Brookhaven National Laboratory
Plant Engineering - E&CS Division
Engineering Change Notice Form

PROJECT: CCWF II **JOB No.** 11705

ECN Title: Cooling Tower Site Plan **ECN No.** 41

Affected Documents: ES-401

401B COOLING TOWER LIGHTING PLAN

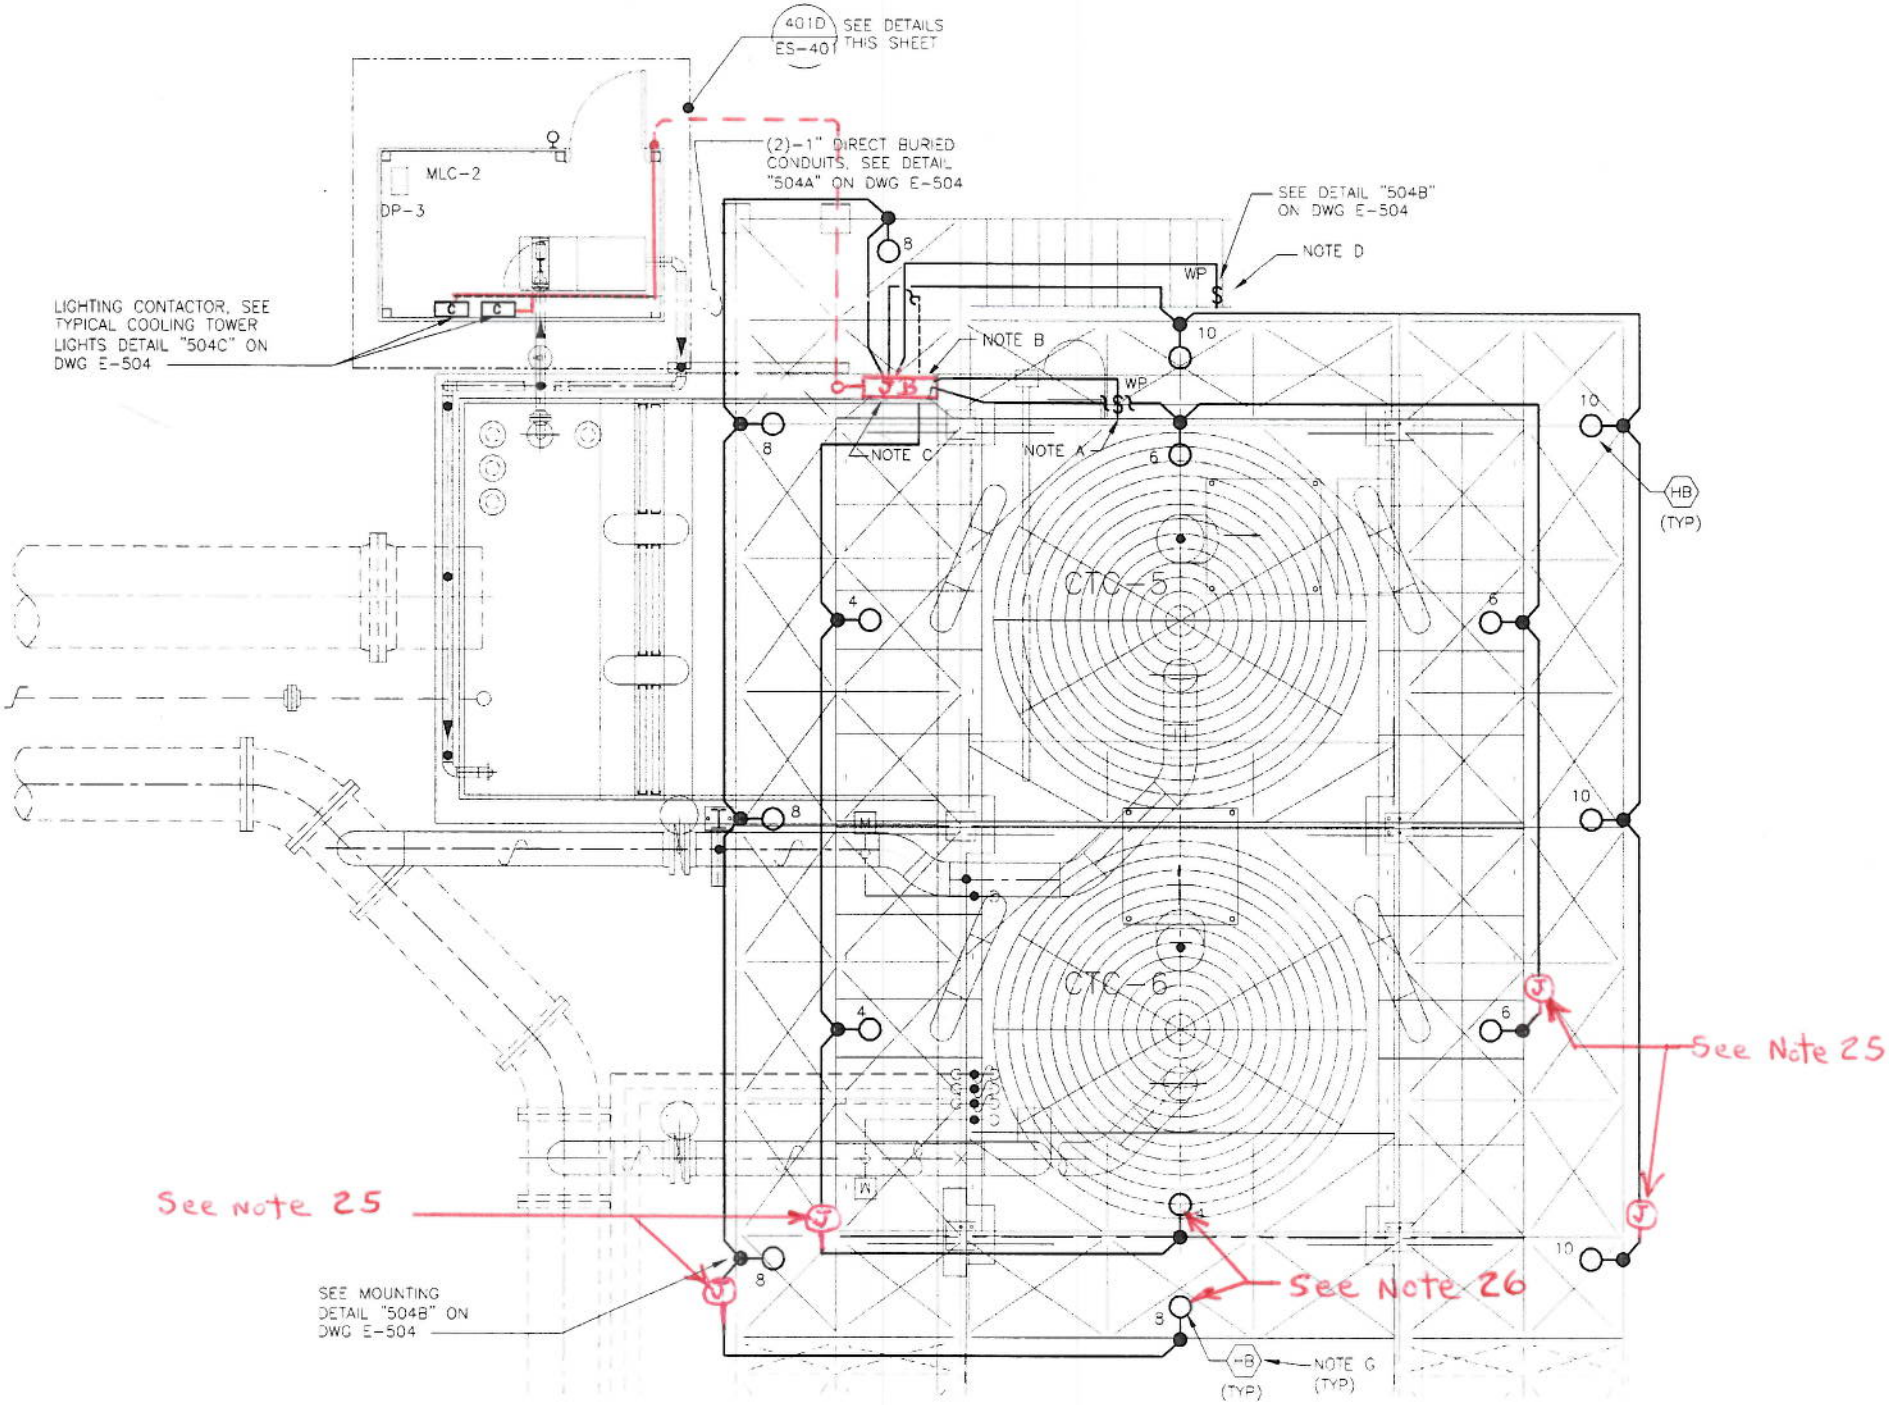
Requested Change (Attach sketch if applicable): COOLING TOWER LIGHTING PLAN:
1. Install junction boxes as shown on the attached sketch to extend lighting circuits to lights for future cooling towers 7, 8, & 9.

Resolution: See attached sketches.

401A COOLING TOWER POWER PLAN

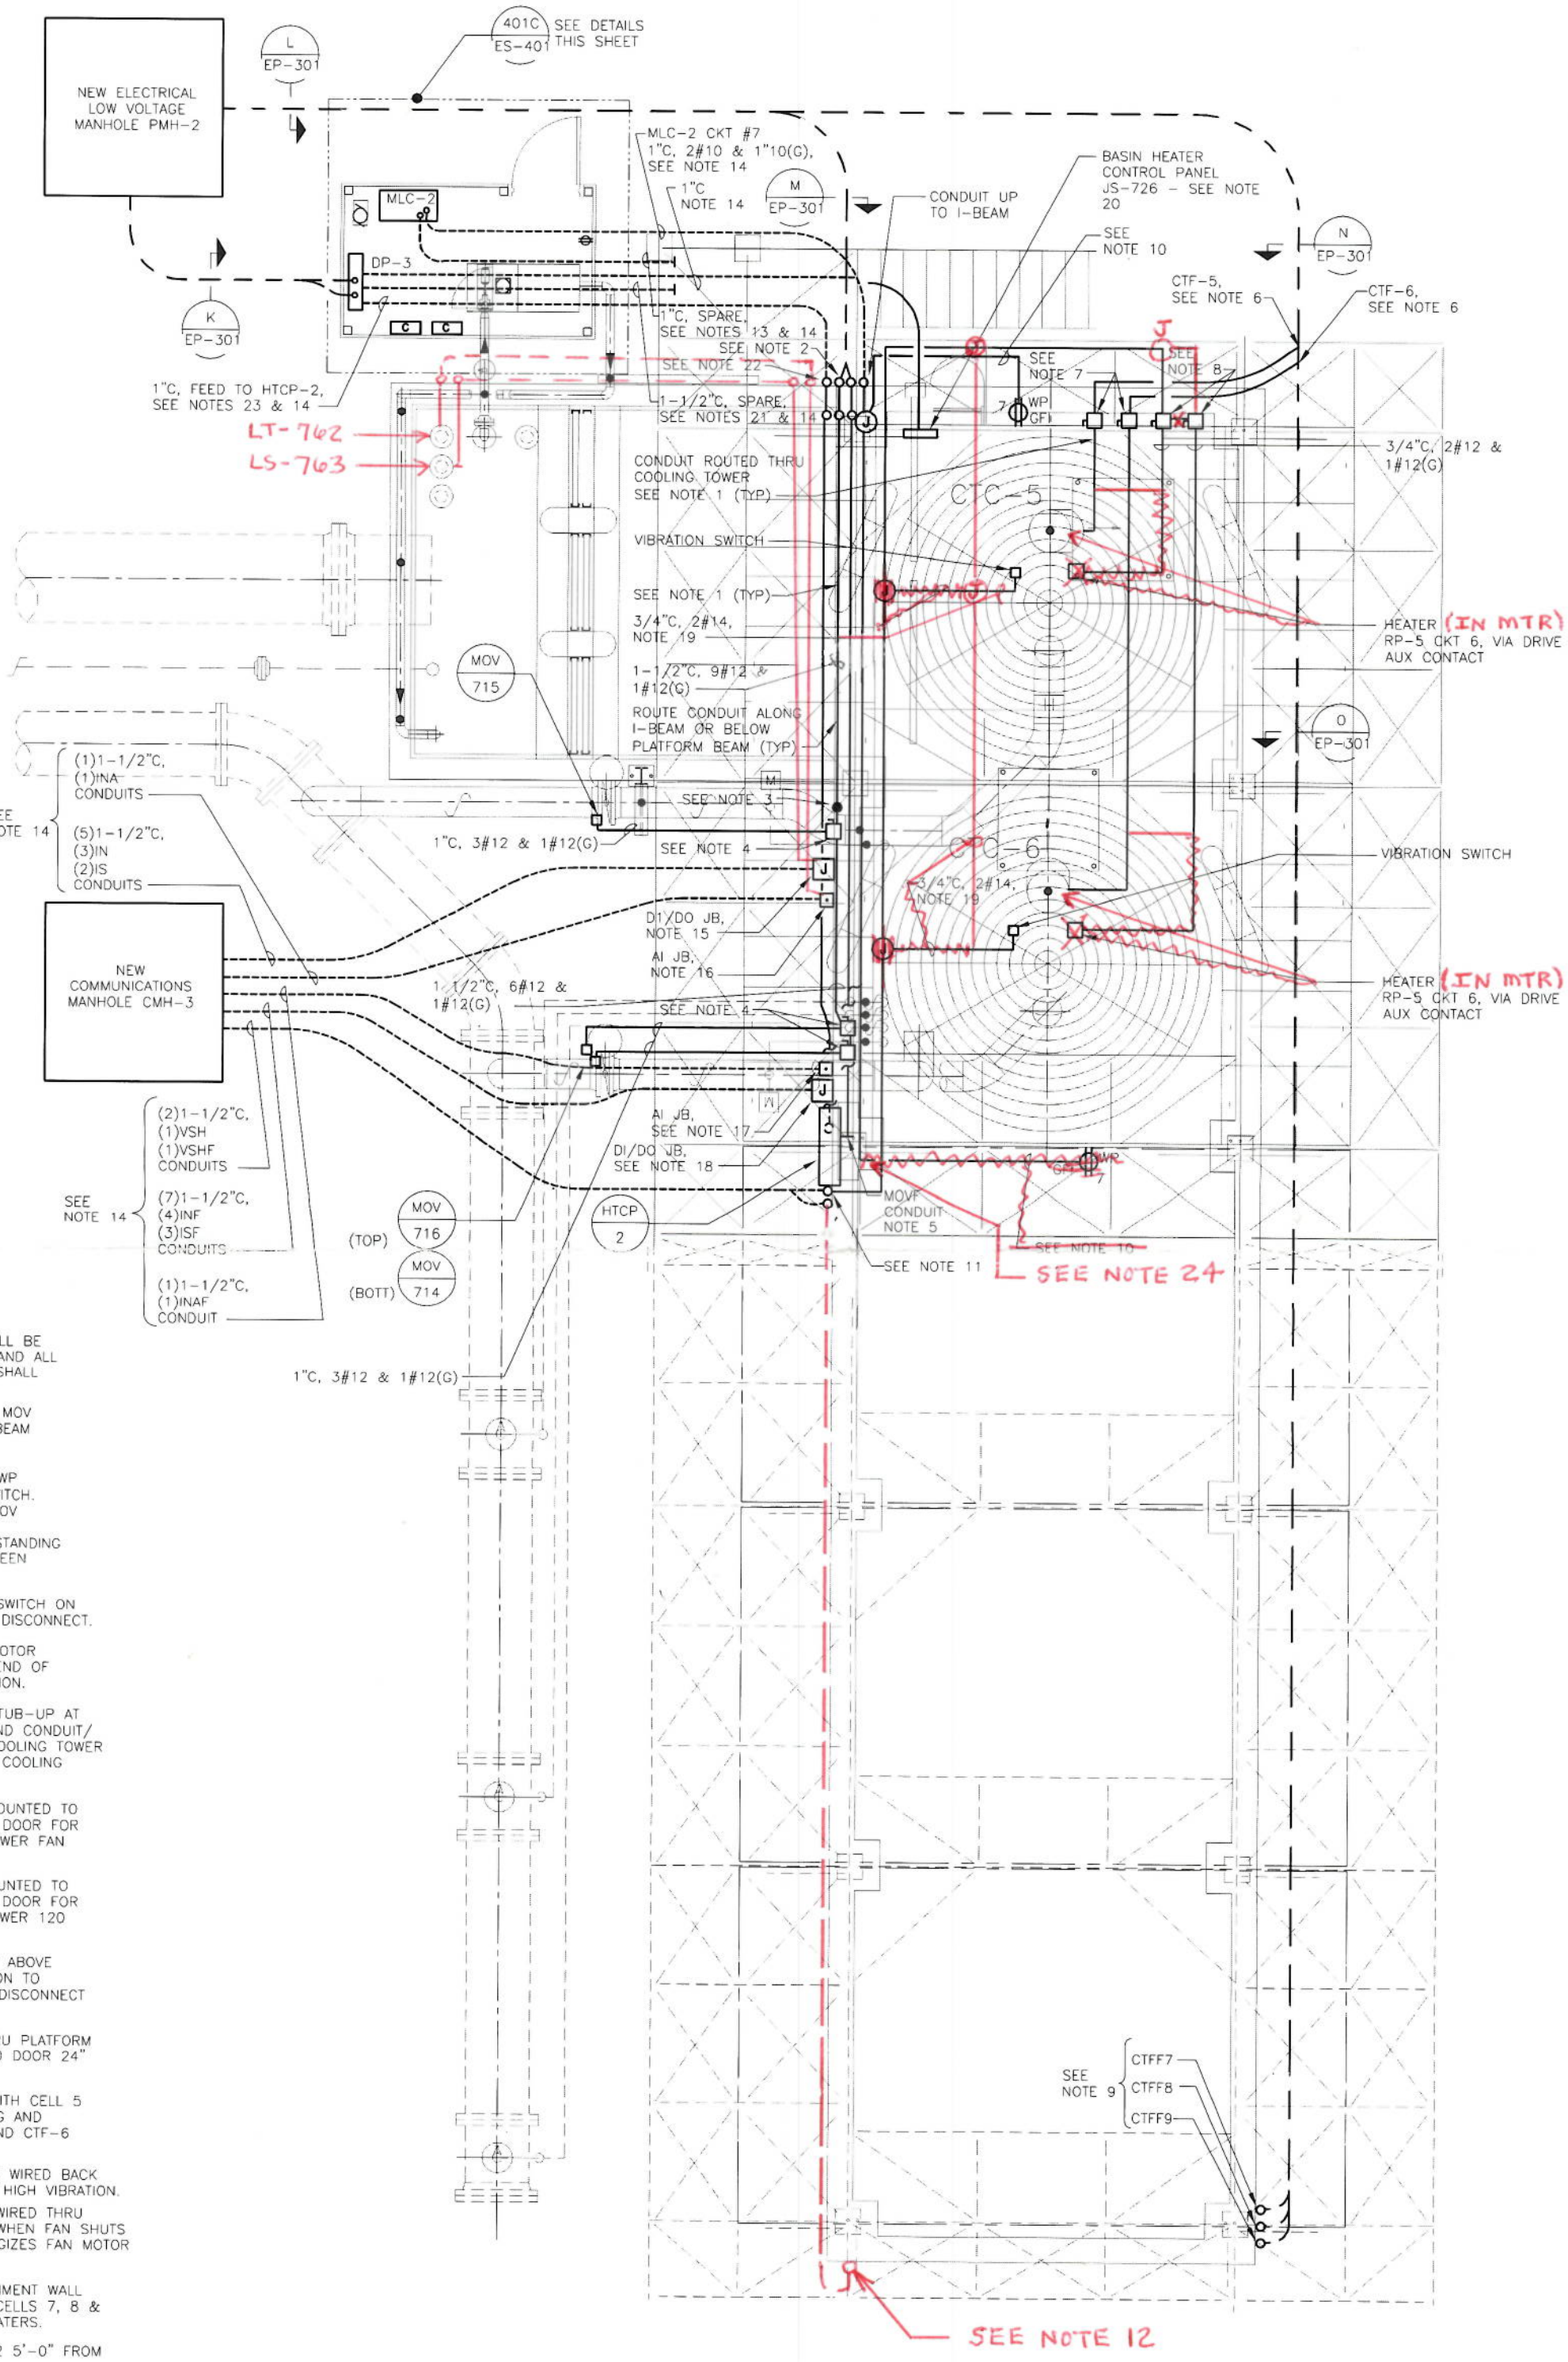
COOLING TOWER POWER PLAN:
1. Do not install receptacle on south end of cooling tower 6. Cap conduit for future extension.

2. Extend 1 ½" conduit below grade for future cooling tower fans 7, 8, & 9 vibration switches to southwest corner of pier for cooling tower 9.

3. All conduit penetrations for motor & motor heater power & vibration switches for cooling tower fans 5 & 6 shall be made on the north end of cooling tower 5.

4. Provide junction box or wiring trough below 30A disconnect switches for cooling tower motor heaters. Run conductors from junction box or wiring trough to each 30A disconnect switch. Do not pull conductors through one disconnect switch to the other as shown on original drawing ES-401.

5. Motor heaters are located inside the cooling tower fan motors. Tee conduits from 30A motor heater disconnect switches into conduits from 200A motor disconnect switches. Run one conduit to each fan motor containing both motor power and heater power conductors.

6. Route 1" conduits from A1 and DI/DO junction boxes to LT-762 & LS-763 on top of cooling twr basin.

12. STUB-UP 1-1/2" CONDUIT ~~AT CONTAINMENT WALL~~ APPROXIMATELY 12" ABOVE GRADE AND CAP FOR FUTURE EXTENSION TO CELLS 7, 8 & 9 VIBRATION SWITCHES AND MOTOR HEATERS.
